Revised proposal for Supplement 5 to the 01 series of amendments to Regulation No. 119 (Cornering lamps)

Note: This informal document is replacing document ECE/TRANS/WP.29/GRE/2015/19. The modifications to the existing text of the Regulation are marked in bold for new or strikethrough for deleted characters.

Figure 3

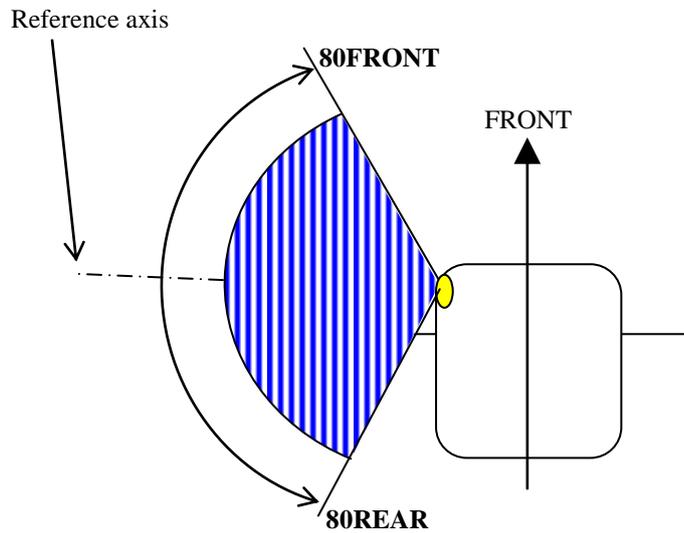
"2.2. Side illuminating lamp

2.2.1. Field of geometric visibility

2.2.1.1. The directions $H = 0^\circ$ and $V = 0^\circ$ correspond to the axis of reference. On the vehicle, they are horizontal, perpendicular to the median longitudinal plane of the vehicle and oriented to the left side of vehicle. They pass through the centre of reference. The values shown in the table give the minimum intensities in cd for the various directions of measurement."

Figure 4

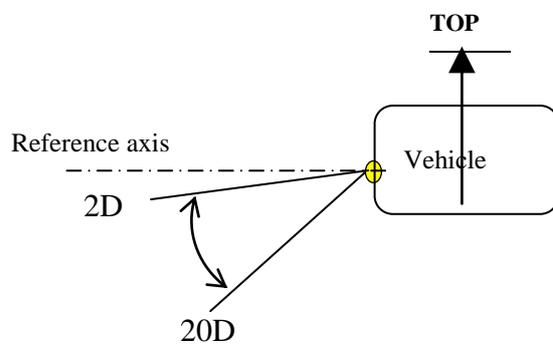
○ = Minimum intensity in cd
